CALL UTILITY NOTIFICATION
CENTER OF COLORADO
1-800-922-1987
CALL 2-BUSINESS DAYS IN ADVANCE
BEFORE YOU DIG, GRADE, OR EXCAVATE
FOR THE MARKING OF UNDERGROUND
MEMBER UTILITIES.

ABERT RANCH SUBDIVISION

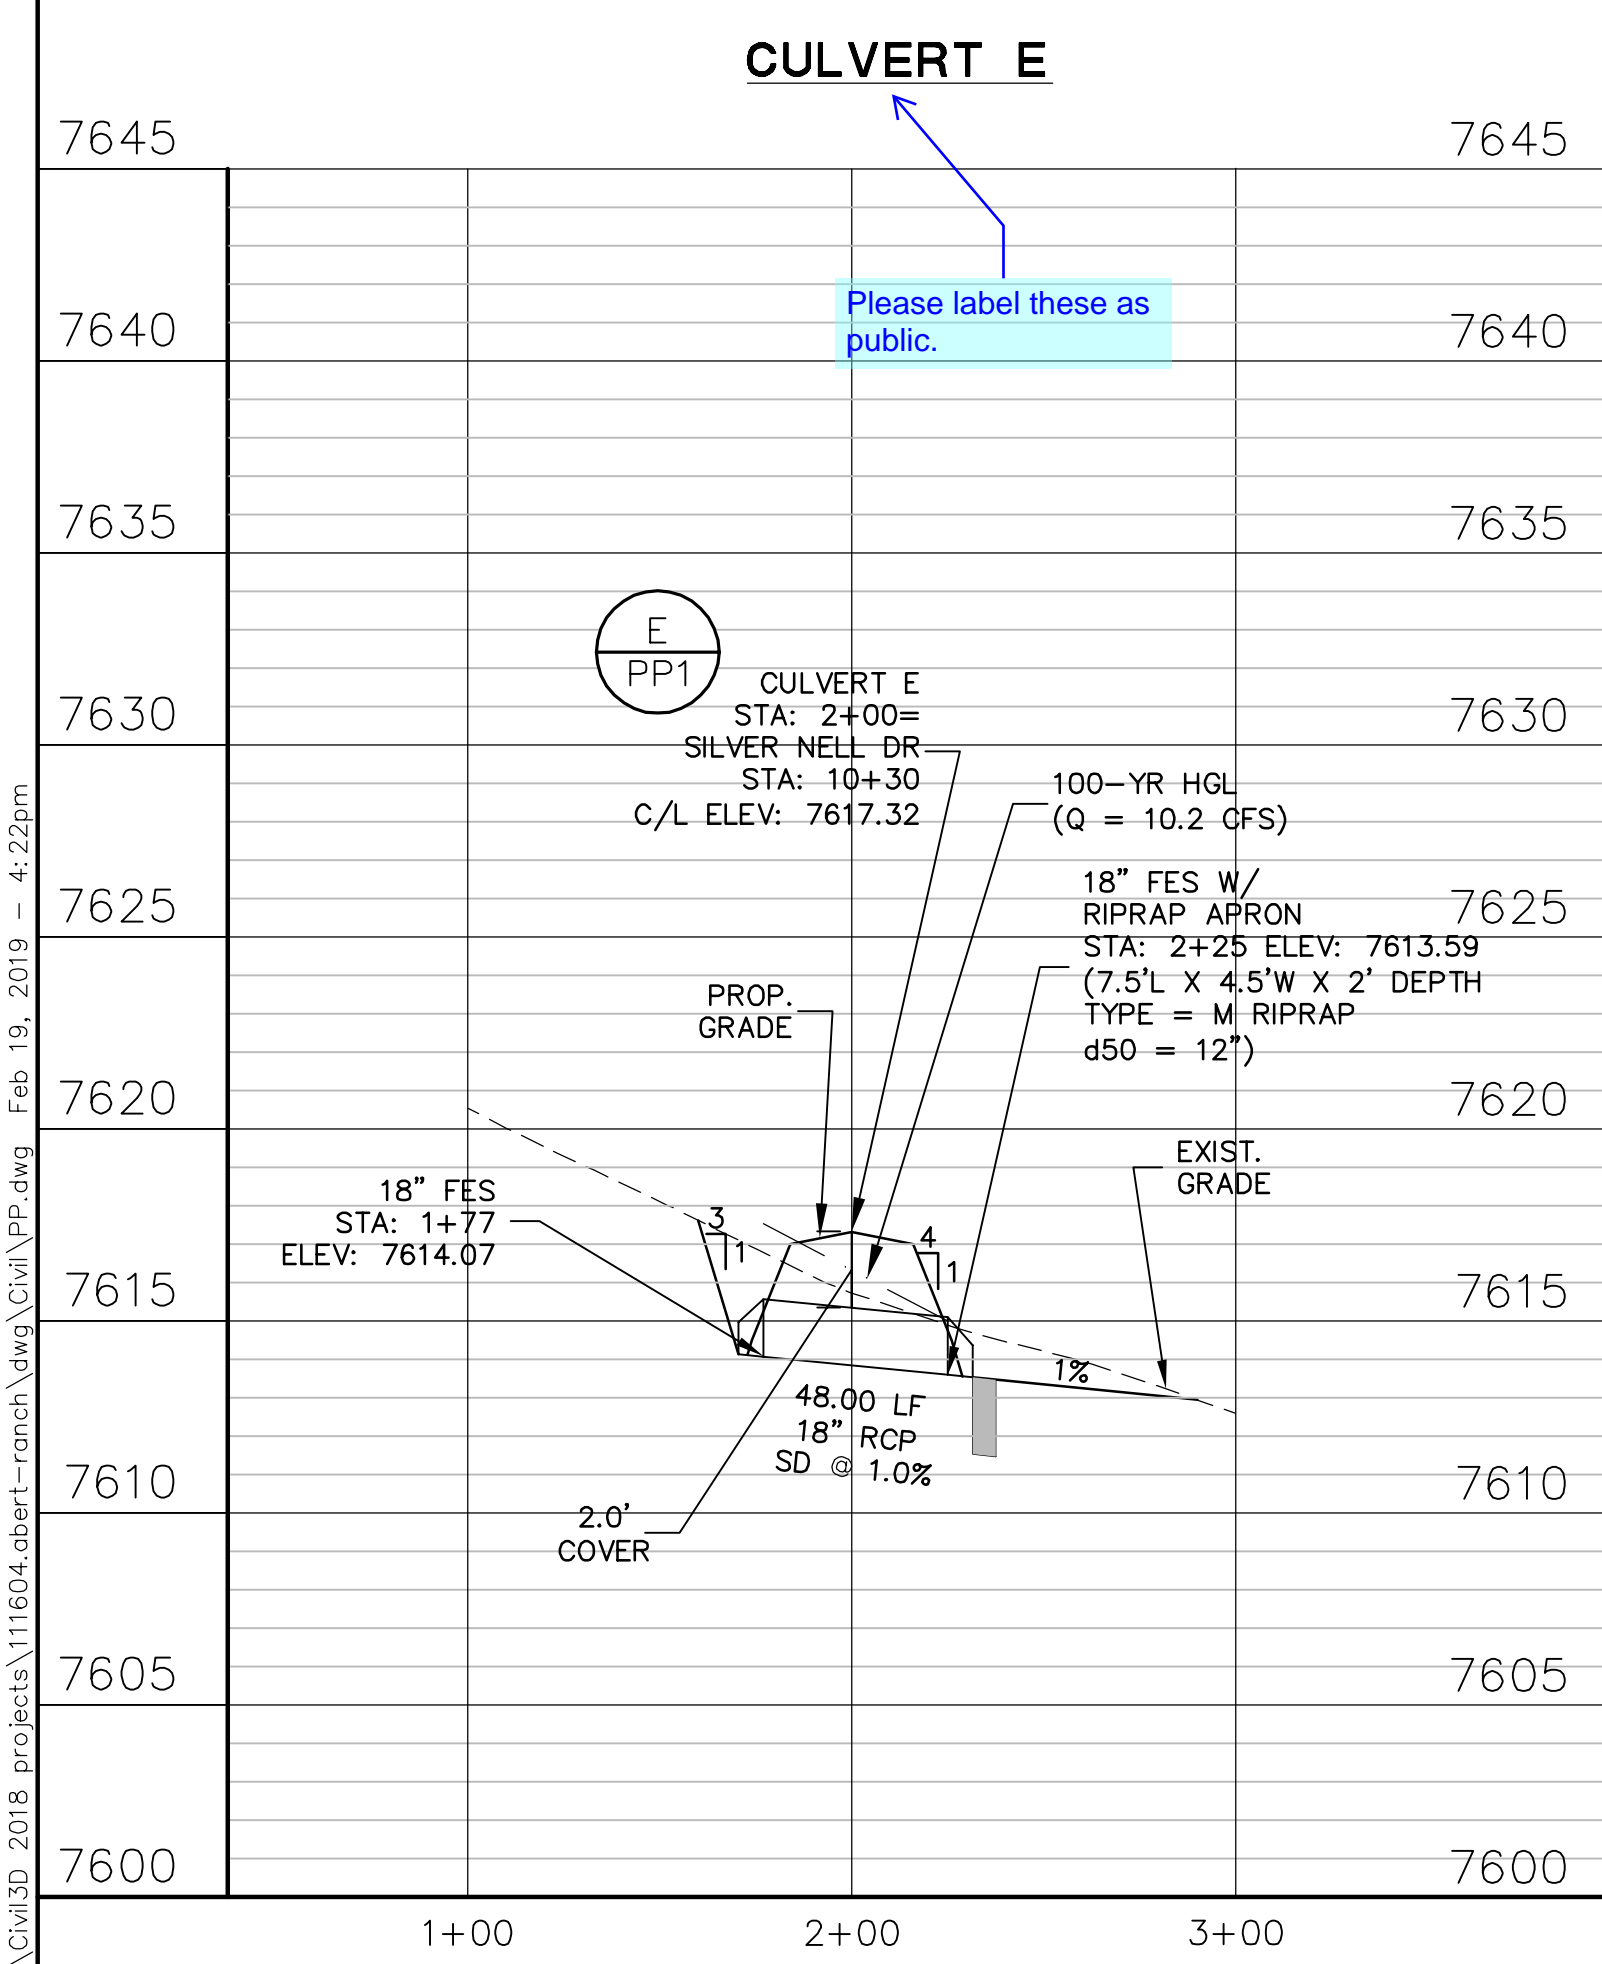
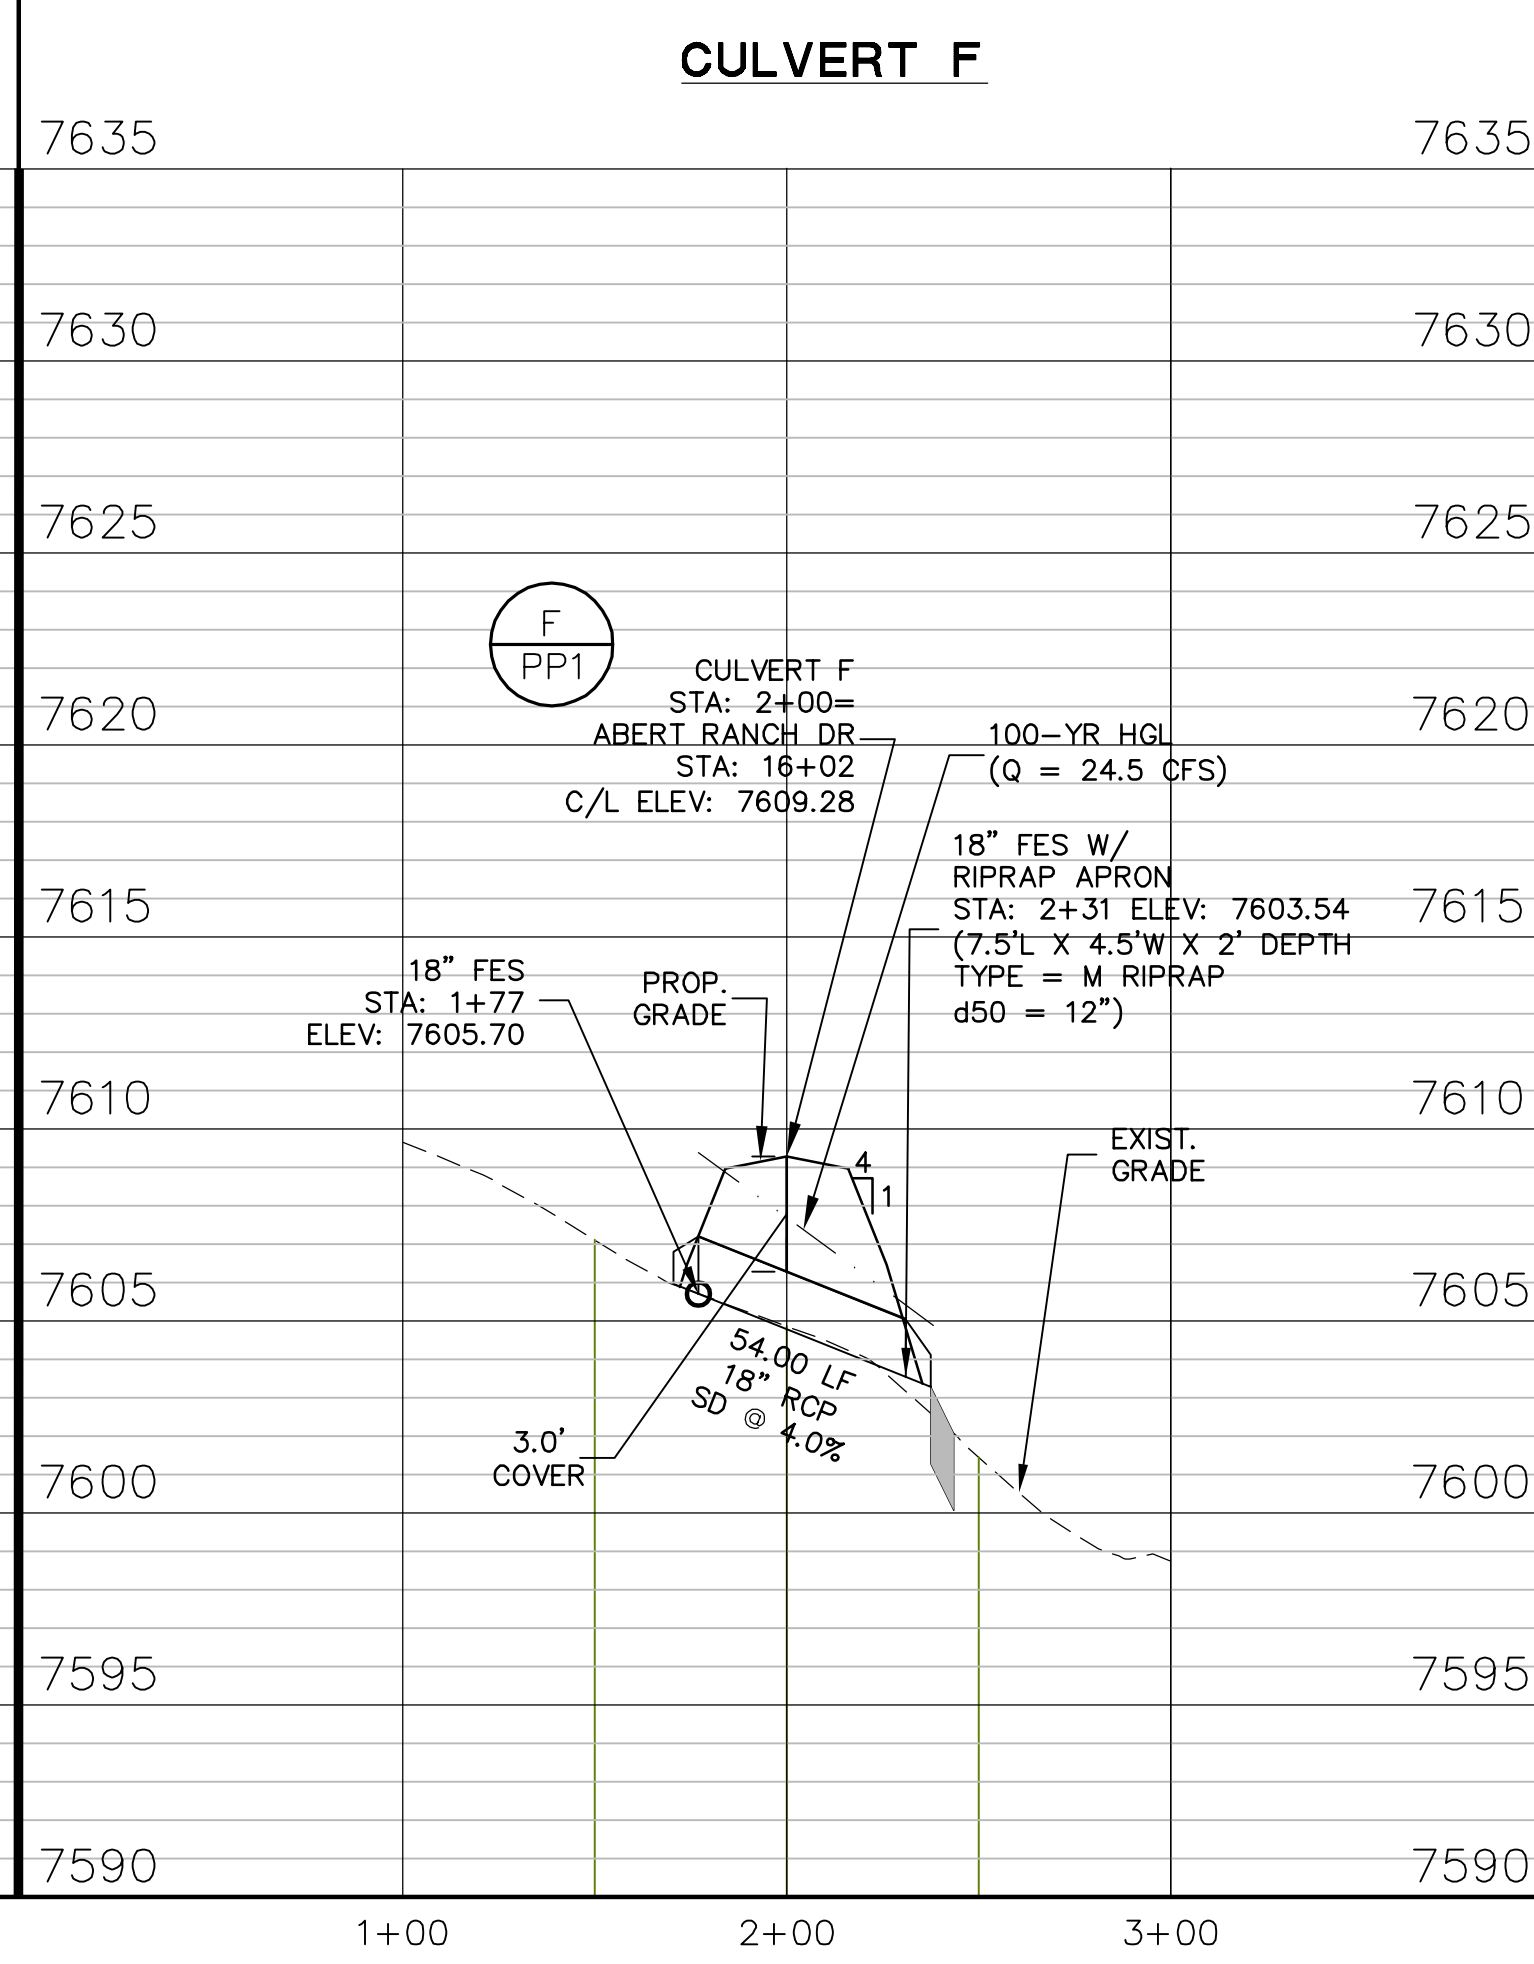
Markup Summary
